Group Title: Virginia Avenue Tunnel

Meeting Title: Virginia Avenue Restoration Project Public Meeting

Date: September 28, 2015

Public Meeting – September 28, 2015
Proposed I Street Connection Fact Sheet

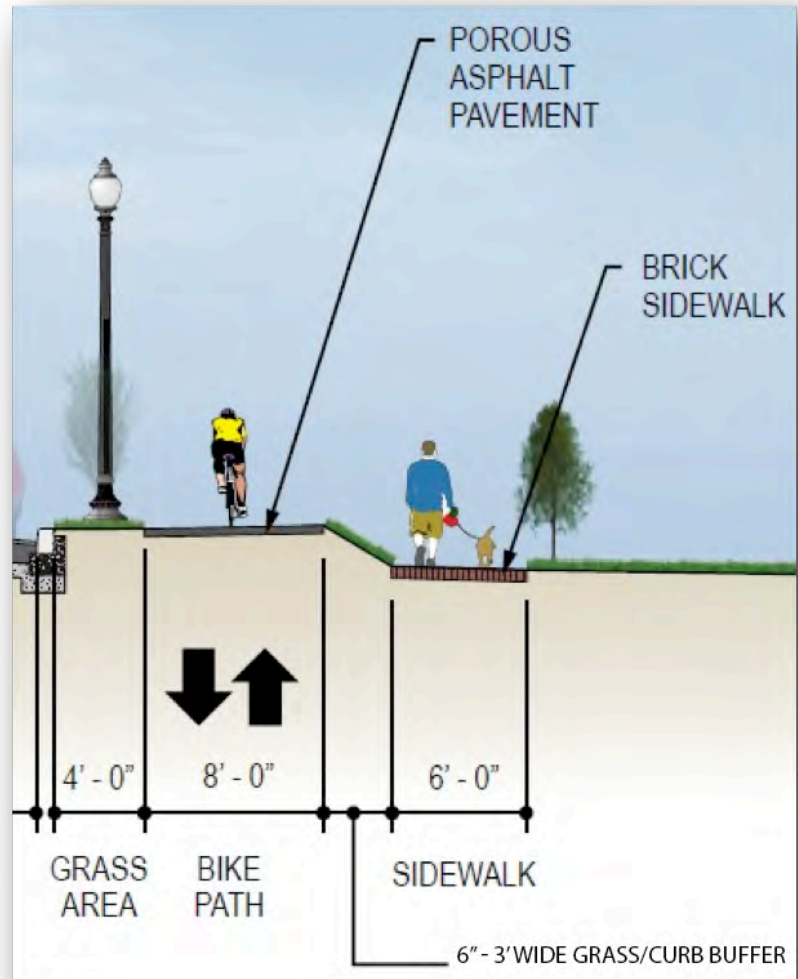
- The NEPA document plans cut off I Street in a cul de sac just east of 4th Street. Based on community feedback, the connection of I Street to the 400 block of Virginia Avenue has been restored.
- Parking Regulation Signs shown on the concept drawings are based on replacing existing signs. These will be revisited based on input from the DDOT parking regulation group to be consistent with the Ballpark Performance Parking district.
- Based on feedback from ANC 6B, the 800 blocks of Virginia Avenue and L Street will be converted to two-way traffic.

- Based on input from the Community Working Group, the Proposed I Street Connection alternative was developed to maintain connection with Virginia Avenue.
- Proposed I Street/Virginia Avenue intersection configuration will be same as existing, providing right-in, right-out connections between Virginia Avenue and I Street.
- Ten parking spaces are provided with the proposed connection, which is the same number of spaces as the existing configuration.
